Fore Peak Ballast Systems and Fore Peak Space Arrangements of Tankers

Rules for the Survey and Construction of Steel Ships Parts H and R
Guidance for the Survey and Construction of Steel Ships Parts D, H, S and R

ID:DX24-19

Amended-Original Requirements Comparison Table
(Fore Peak Ballast Systems and Fore Peak Space Arrangements of Tankers)

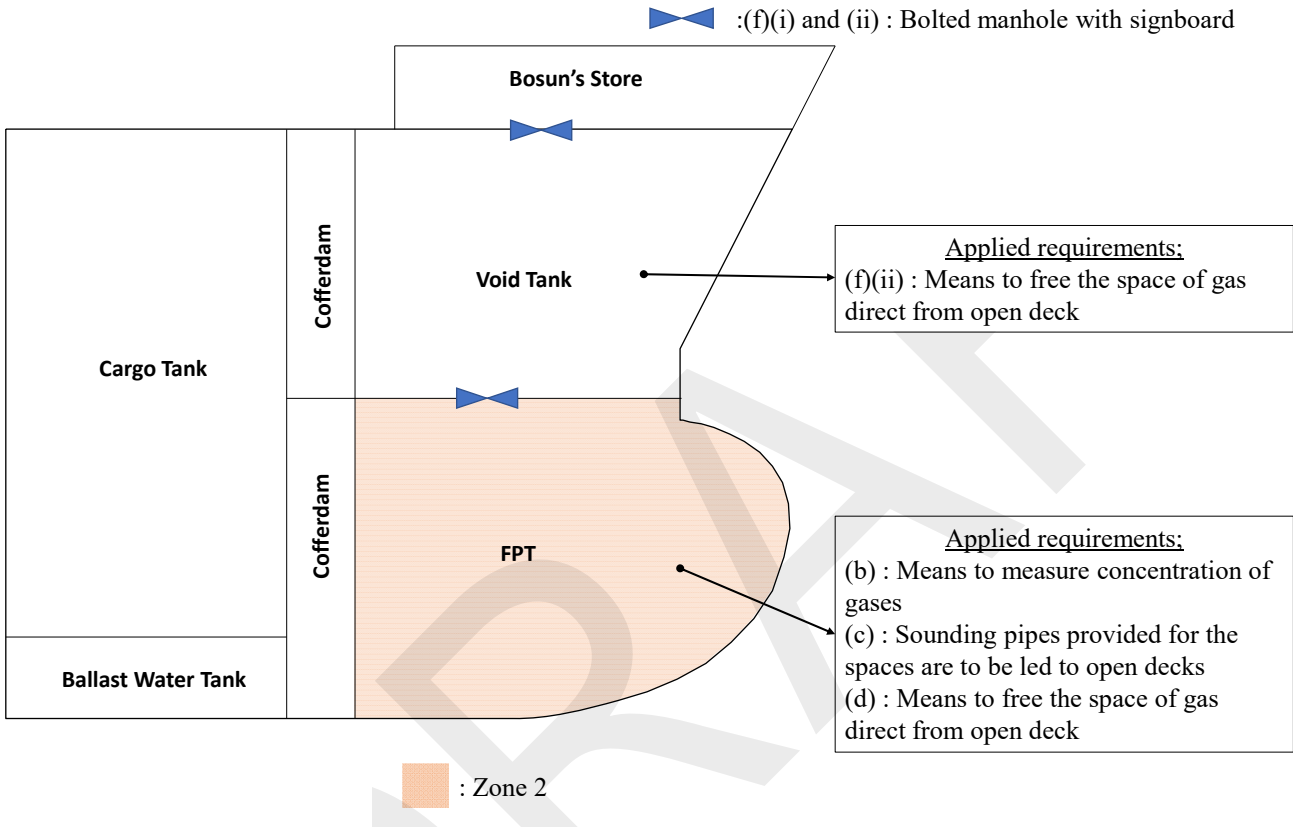
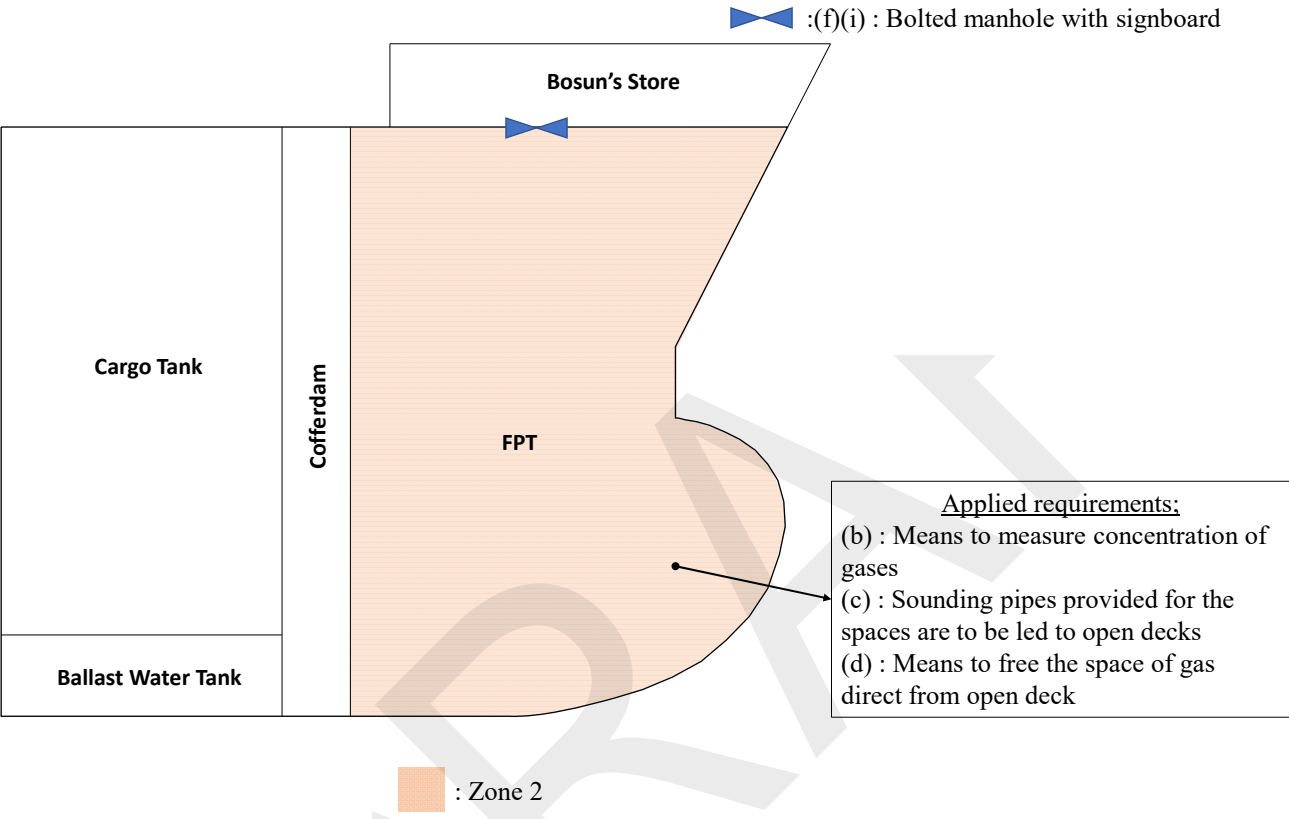
Amended	Original	Remarks
<p>following requirements are to be complied with <u>(samples of the arrangements and the applicable provisions to forward ballast tanks and enclosed spaces are shown in Fig. D14.3.2)</u>:</p> <p>(a) In applying the requirements specified in Part H of the Rules, forward ballast tanks are to be considered to be hazardous areas in <u>either of the following (i) or (ii) cases</u>:</p> <p>(i) <u>In cases where forward ballast tanks are adjacent to cargo oil tanks, said tanks are considered to be Zone 1 as specified in 4.3.1(2)(c), Part H of the Rules.</u> Vent pipe openings provided for forward ballast tanks are to be located on open decks at an appropriate distance of not less than 3 <i>m</i> away from any sources of ignition. In addition, the area around such vent pipe openings is defined as a hazardous area in accordance with 4.3.1(2)(i), Part H of the Rules and 4.3.1(3)(a), Part H of the Rules. <u>This, however, does not apply to the sounding pipe openings and manholes of forward ballast tanks.</u></p> <p>(ii) <u>In cases where forward ballast tanks are separated from the cargo oil tanks by cofferdams, said tanks are considered to be Zone 2 as specified in 4.3.1(3)(h), Part H of the Rules. In such cases, vent pipe openings provided for forward ballast tanks are to be located on open decks.</u></p> <p>(b) Means are to be provided, on open decks, to allow measurement of the concentration of <u>toxic and flammable gases</u> within forward ballast tanks. In</p>	<p>following requirements are to be complied with:</p> <p>(a) In applying the requirements specified in Part H of the Rules, forward ballast tanks are to be considered to be hazardous areas as specified in 4.3.1(2)(c), Part H of the Rules.</p> <p>(b) Vent pipe openings provided for forward ballast tanks are to be located on open decks at an appropriate distance of not less than 3 <i>m</i> away from any sources of ignition. In addition, the area around such vent pipe openings is defined as a hazardous area in accordance with 4.3.1(2)(i), Part H of the Rules and 4.3.1(3)(a), Part H of the Rules.</p> <p style="text-align: center;">(Newly added)</p> <p>(c) Means are to be provided, on open decks, to allow measurement of the concentration of flammable gases within forward ballast tanks. In this case,</p>	<p>IACS UR F44 Rev.3 para.1.1g)</p>

Amended	Original	Remarks
<p>this case, such means may be a combination of <u>sampling pipes and portable detecting instruments specified in 4.5.7(2)(a), Part R of the Rules or 13.2.1, Part S of the Rules</u>. Such sampling pipes may be those sounding pipes specified in the following <u>(c)</u> in cases where deemed appropriate by the Society.</p> <p><u>(c)</u> Sounding pipes provided for forward ballast tanks are to be led to open decks.</p> <p><u>(d)</u> <u>Means to free forward ballast tanks of gas direct from open decks are to be provided.</u></p> <p><u>(e)</u> Access into forward ballast tanks is to be direct from open decks.</p> <p><u>(f)</u> <u>Notwithstanding (e) above, indirect access from open decks into the forward ballast tanks through enclosed spaces such as cofferdams (hereinafter referred to as “entry spaces”)</u> may be acceptable provided that the following <u>(i) to (iii)</u> are satisfied.</p> <p><u>(i)</u> Access into forward ballast tanks <u>is</u> to be a gas tight bolted manhole. In this case, a warning sign is to be provided at the manhole stating that the forward ballast tank may only be opened after it has been proven to be <u>toxic and flammable gas</u> free or the electrical equipment which is not electrically safe in <u>the forward ballast tank</u> is isolated.</p> <p><u>(ii)</u> <u>In cases where entry spaces are accessed through other enclosed spaces such as a</u></p>	<p>such means may be a combination of <u>portable detecting instruments and sampling pipes</u>. Such sampling pipes may be those sounding pipes specified in the following <u>(d)</u> in cases where deemed appropriate by the Society.</p> <p><u>(d)</u> Sounding pipes provided for forward ballast tanks are to be led to open decks.</p> <p>(Newly added)</p> <p><u>(e)</u> Access into forward ballast tanks is to be direct from open deck. <u>However</u>, indirect access from open decks into the forward ballast tanks through enclosed spaces may be acceptable provided that the following <u>(i) or (ii)</u> is satisfied.</p> <p><u>(i)</u> <u>In cases where enclosed spaces are separated from the cargo oil tanks, access into forward ballast tanks are</u> to be a gas tight bolted manhole <u>located in such enclosed spaces</u>. In this case, a warning sign is to be provided at the manhole stating that the forward ballast tank may only be opened after it has been proven to be <u>gas</u> free or the electrical equipment which is not electrically safe in <u>the enclosed space</u> is isolated.</p> <p>(Newly added)</p>	<p>IACS UR F44 Rev.3 para.1.1d)</p> <p>IACS UR F44 Rev.3 para.1.1e)</p> <p>IACS UR F44 Rev.3 (e), (f): para.1.1b)</p> <p>(f)(i): para.1.1b) (f)(ii): para.2.2a), b) (f)(iii): para.2.1</p>

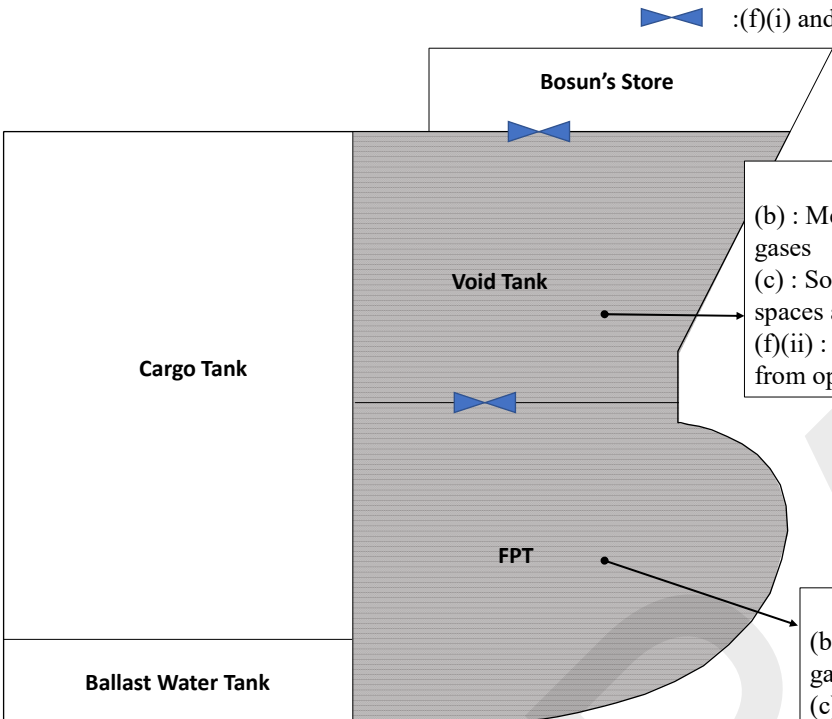
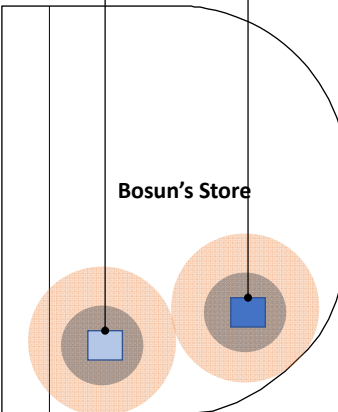
Amended	Original	Remarks
<p>(Sample 2) Applicable to both oil tankers and chemical tankers</p>  <p>The diagram illustrates the fore peak space arrangement. On the left, there is a vertical stack of a Cargo Tank (top) and a Ballast Water Tank (bottom). To the right of the Ballast Water Tank is a Cofferdam. Further right is the FPT (Fore Peak Tank), which is shaded in light orange. A Bosun's Store is located at the top of the FPT. Two blue butterfly symbols represent manholes: one on the top surface of the FPT and another on the top surface of the Bosun's Store. A legend at the bottom left shows an orange square representing Zone 2. A text box on the right lists <u>Applied requirements:</u> (b) : Means to measure concentration of gases, (c) : Sounding pipes provided for the spaces are to be led to open decks, and (d) : Means to free the space of gas direct from open deck. A legend at the top right shows a blue butterfly symbol representing (f)(i) : Bolted manhole with signboard.</p>

Amended	Original	Remarks
Fig. S1.3.1-3		
<p>(Sample 1) Applicable</p>	<p>(Sample 2) Applicable</p>	<p>IACS UI SC211 Rev.1 Figure 2</p>
<p>(Sample 3) Applicable</p>	<p>(Sample 4) Applicable</p>

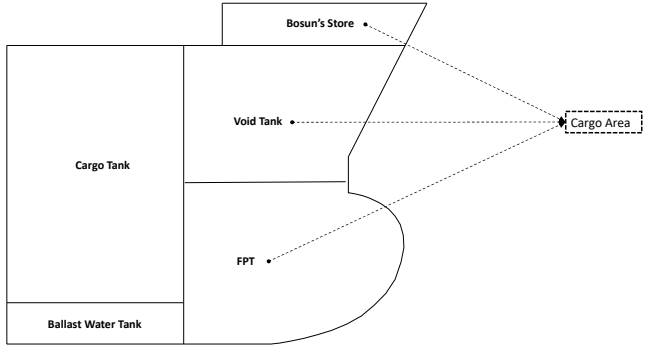
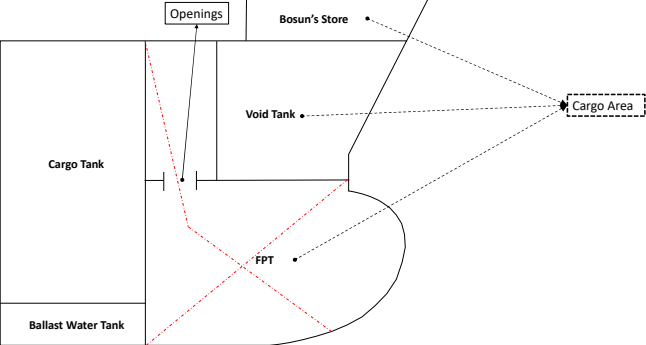
Amended	Original	Remarks
<p align="center">GUIDANCE FOR THE SURVEY AND CONSTRUCTION OF STEEL SHIPS</p> <p align="center">Part S SHIPS CARRYING DANGEROUS CHEMICALS IN BULK</p> <p align="center">S1 GENERAL</p> <p>S1.3 Definitions</p> <p>S1.3.1 Definitions</p> <p>2 The term “cargo area” referred to 1.3.1(5), Part S of the Rules <u>is to be as follows.</u></p> <p>(1) <u>The area excludes the fuel oil tanks adjacent to the cargo tanks or slop tanks of the arrangement as given in Fig. S1.3.1-1. However, the requirements specified in 3.4, Part S of the Rules apply.</u></p> <p>(2) <u>A non-hazardous area in the forecastle space which is protected from cargo tanks by cofferdams, etc. is not to be defined as part of the cargo area. However, compartments located above cofferdams, etc. protecting non-hazardous areas are to be defined as part of the cargo area (refer to Fig. S1.3.1-3).</u></p>	<p align="center">GUIDANCE FOR THE SURVEY AND CONSTRUCTION OF STEEL SHIPS</p> <p align="center">Part S SHIPS CARRYING DANGEROUS CHEMICALS IN BULK</p> <p align="center">S1 GENERAL</p> <p>S1.3 Definitions</p> <p>S1.3.1 Definitions</p> <p>2 The term “cargo area” referred to 1.3.1(5), Part S of the Rules excludes the fuel oil tanks adjacent to the cargo tanks or slop tanks of the arrangement as given in Fig. S1.3.1-1. However, the requirements specified in 3.4, Part S of the Rules apply.</p> <p>(Newly added)</p>	<p>IACS UI SC211 Rev.1 Interpretation 2</p>

Fig. R3.2.6

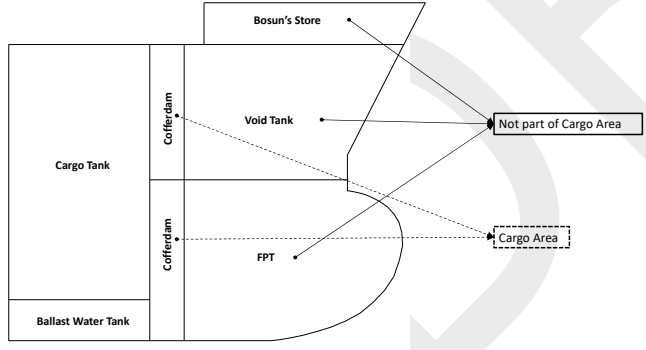
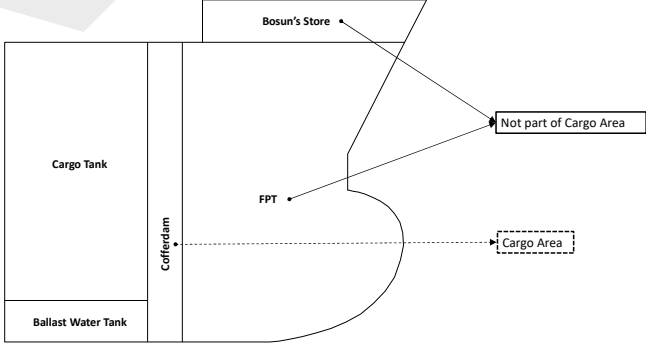
Amended	Original	Remarks
<p align="center">GUIDANCE FOR THE SURVEY AND CONSTRUCTION OF STEEL SHIPS</p> <p align="center">Part R FIRE PROTECTION, DETECTION AND EXTINCTION</p> <p align="center">R3 DEFINITIONS</p> <p>R3.2 Definitions</p> <p><u>R3.2.6 Cargo Area</u> <u>The “cargo area” referred to 3.2.6, Part R of the Rules does not include non-hazardous areas in forecastle spaces that are protected from cargo tanks by cofferdams, etc.. However, it does include compartments located above cofferdams, etc. protecting non-hazardous areas (refer to Fig. R3.2.6).</u></p> <p align="center">  </p>	<p align="center">GUIDANCE FOR THE SURVEY AND CONSTRUCTION OF STEEL SHIPS</p> <p align="center">Part R FIRE PROTECTION, DETECTION AND EXTINCTION</p> <p align="center">R3 DEFINITIONS</p> <p>R3.2 Definitions (Newly added)</p> <p align="center">  </p>	<p>IACS UI SC211 Rev.1 Interpretation 2</p> <p>IACS UI SC211 Rev.1 Figure 2</p>

Amended	Original	
<p style="text-align: center; font-size: small;">(Sample 3) Applicable to both oil tankers and chemical tankers</p>	<p style="text-align: center; font-size: small;">(Sample 4) Applicable to both oil tankers and chemical tankers</p>	
<p style="text-align: center; font-size: small;">(Sample 5) Applicable to oil tankers only</p>	<p style="text-align: center; font-size: small;">(Sample 6) Applicable to oil tankers only</p>
